SAFETY EVALUATION REPORT

Docket No. 72-1027
TN-68 Dry Storage Cask
Certificate of Compliance No. 1027
Amendment No. 1

Figure 1 – Example TN-68 Cask Storage Configuration (Based on SAR Figure 4.10-1)

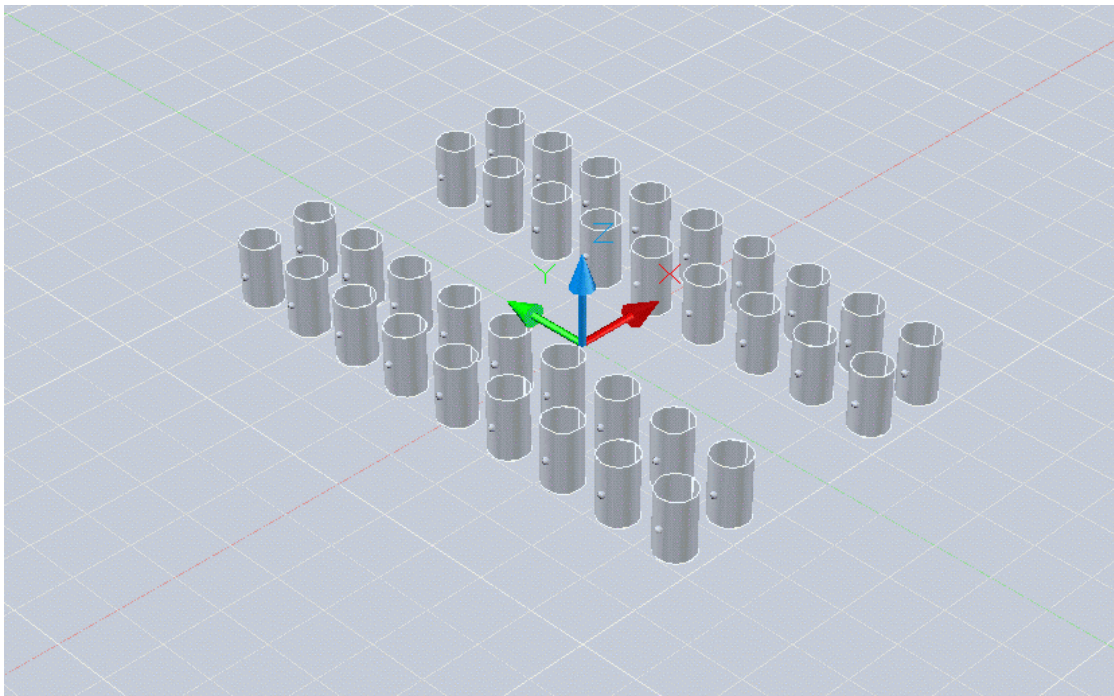
The staff reviewed the applicant's approach for determining the view factor for radiative exchange from the cask surface to the environment (which used an engineering textbook correlation rather than an actual calculation) and determined that it was a non-conservative approach.

To more precisely evaluate the level of conservatism in the results obtained with the proposed methodology, the staff constructed a view factor computation model for a fully loaded TN-68 cask in a typical storage array (as illustrated in Figure 4.10-1 of 72-1027 TN-68 Amendment 1 SAR, Rev. 0, 01/05). This model was developed using RadCad® v5.0, which determines view factors between specified geometric shapes by means of ray-tracing. A graphical representation of the RadCad® v5.0 model is shown in Figure 1 below.

The staff determined that the view factor of the emitting cask in Figure 1 to the environment, with the concrete storage pads and access road conservatively considered to have no communication with the cask surface, was approximately 0.33. The applicant's original value of 0.62 for the view factor was considered to be non-conservative.

The staff requested that the applicant submit a calculation of the view factor in order to more appropriately capture the actual behavior of radiative exchange between a cask in an array of casks situated on a storage pad. The applicant submitted a view factor calculation that utilized

the radiosity method of the ANSYS FEA code, and completed a sensitivity study of the effect of variations of the view factor on the thermal performance of the cask. The applicant documented this effort in Sections 4.10.1.1 and 4.10.1.3 of the SAR.

The staff reviewed the ANSYS model that was submitted by the applicant and found some minor errors related to the mirror plane and the resolution of the view factor calculation in the submitted model. The staff discussed the issues with the applicant, and, by letter dated March 16, 2007, the applicant provided a revised model that the staff found acceptable.

The applicant should use the modeling approach accepted by the staff for any future calculations related to the exchange of radiation between the cask and the surrounding environment for the TN-68 cask design. The applicant must consider the geometry of the cask storage pad when evaluating site specific application of the TN-68 cask design at a storage facility, since their view factor calculation method is dependent on the pad geometry.
